THE ROVER COMPANY LIMITED

LAND-ROVER SERVICE NEWS LETTER
No. 26

September, 1962

Item 132 SUBJECT: CLUTCH MECHANISM

Fig. 2. Late type clutch mechanism

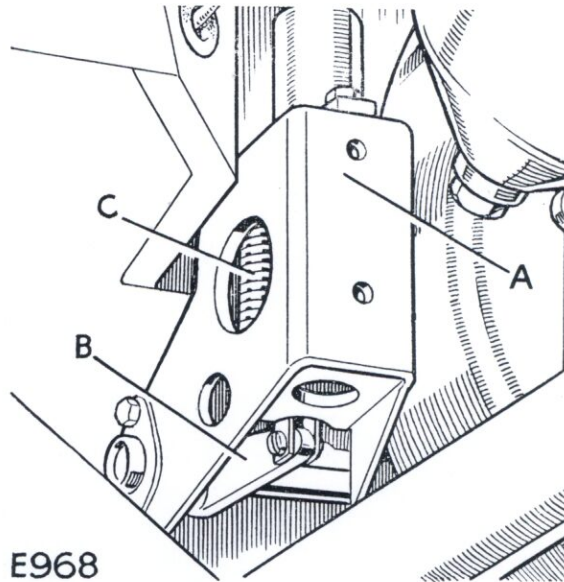
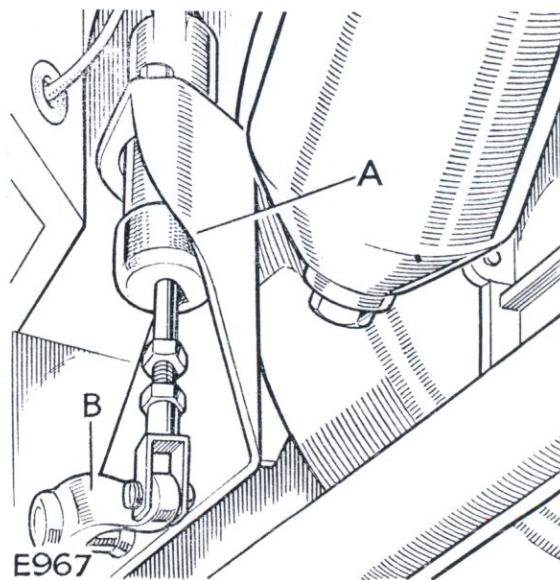
MODIFICATION: Introduction of hydrostatic clutch, that is, clutch mechanism which requires no adjustment for the life of the clutch plate.

Models with the latest type clutch mechanism can be easily identified as follows:

- (a) The support bracket for clutch slave cylinder on early models encloses the cylinder; on late models the cylinder is exposed.
- (b) The operating lever on early models is straight, but on late models it is cranked.
- (c) Return spring is not fitted to the operating lever on late models.

All these differences are clearly shown at Figs. 1 and 2.

Fig. 3. Setting hydrostatic clutch linkage, Method A

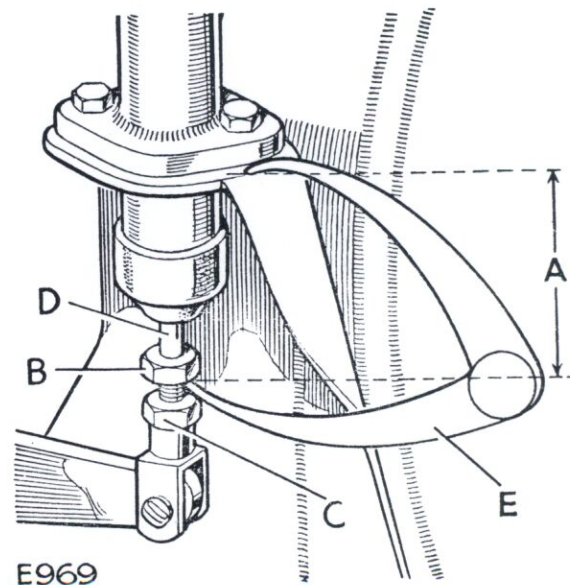
- (b) Adjust the push rod if necessary by slackening off lock nut 'C', and rotating push rod with the fingers to give dimension 'A' as shown as Fig. 3. Do not adjust nut 'B' to obtain this figure. Nut 'B' must always be tightened to the end of the push rod thread.

A— $1\frac{7}{8}$ in. (48 mm)

B—Nut must always be at end of push rod thread

C—Lock nut for push rod

D—Check dimension with calipers as shown

Early Land-Rover Series II and IIA models can be modified by fitting the new parts detailed above, discarding the return spring for operating lever and adjusting the push rod as shown at Fig. 3.

Fig. 4. Setting hydrostatic clutch, Method B

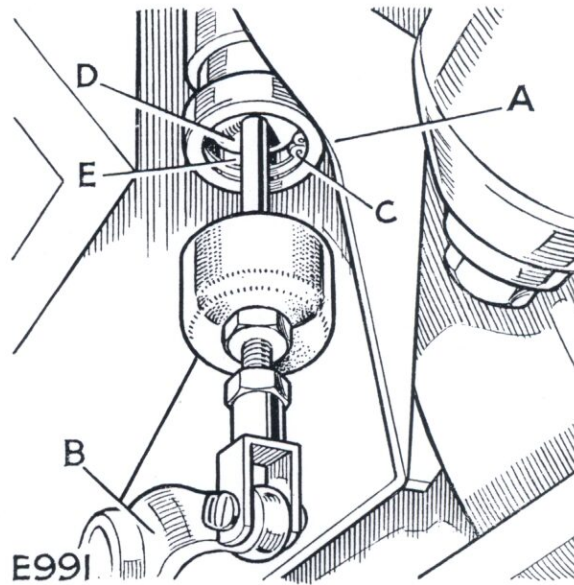
- (c) Fully depress clutch pedal and withdraw rubber boot on cylinder. Then adjust push rod until there is approximately $\frac{1}{8}$ in. (3 mm) clearance between bottom of piston and circlip. See Fig. 4.

A—Exposed slave cylinder
 B—Cranked operating rod
 C—Circlip
 D—Piston
 E— $\frac{1}{8}$ in. (3 mm)
